**NSL - 8779**

**ADMINISTRATIVE APPLICATION CHECKLIST**

Re: Application for Unorthodox Well Location  
OLD INDIAN DRAW UNIT COM #4H – API # 30-015-55066  
Surface Location: 940' FSL, 205' FEL, Section 17, T22S, R28E  
Proposed First Take Point: 880' FSL, 330' FEL, Section 17, T22S, R28E  
Proposed Last Take Point: 880' FSL, 100' FWL, Section 18, T22S, R28E (**Unorthodox**)

WELL LOCATION AND ACREAGE DEDICATION PLAT

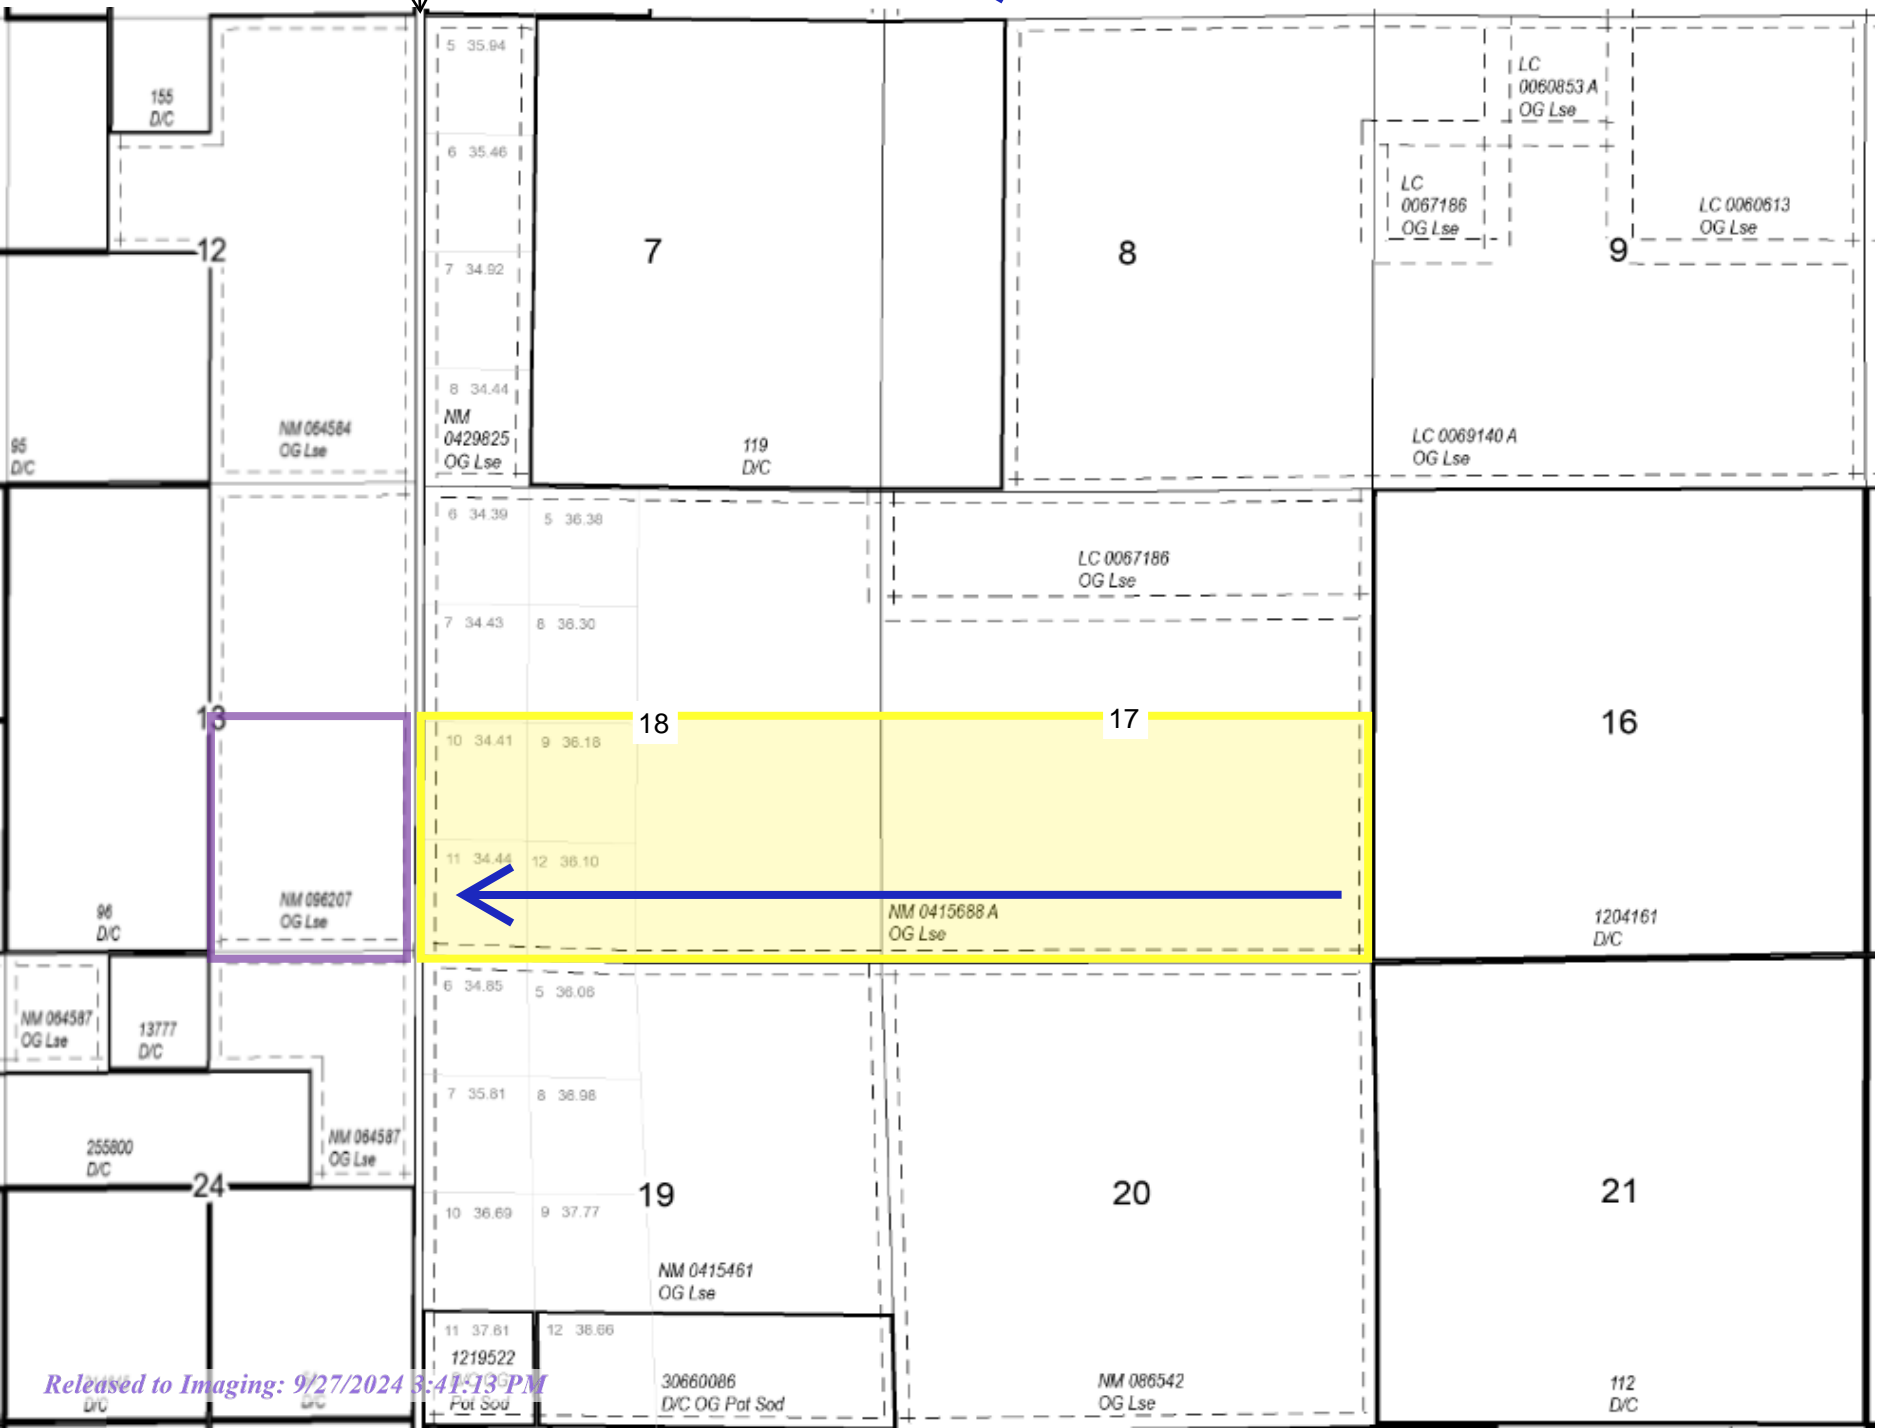
There appears to be some erroneous information pertaining to the Well location.

Please verify the information on the details of your applications.

The APD C-102, the NSL C-102 and the NSL letter have footage information that are not consistent.

I apologize for the typographical errors. As we discussed over the phone this morning, here is the correct info for both the Old Indian Draw Unit Com Well No. 4H and the Old Indian Draw Unit Com Well No. 9H wells:

Surface Location: 930' FSL, 205' FEL, Section 17, T22S, R28E

Proposed First Take Point: 880' FSL, 330' FEL, Section 17, T22S, R28E

Proposed Last Take Point: 880' FSL, 100' FWL, Section 18, T22S, R28E (Unorthodox)
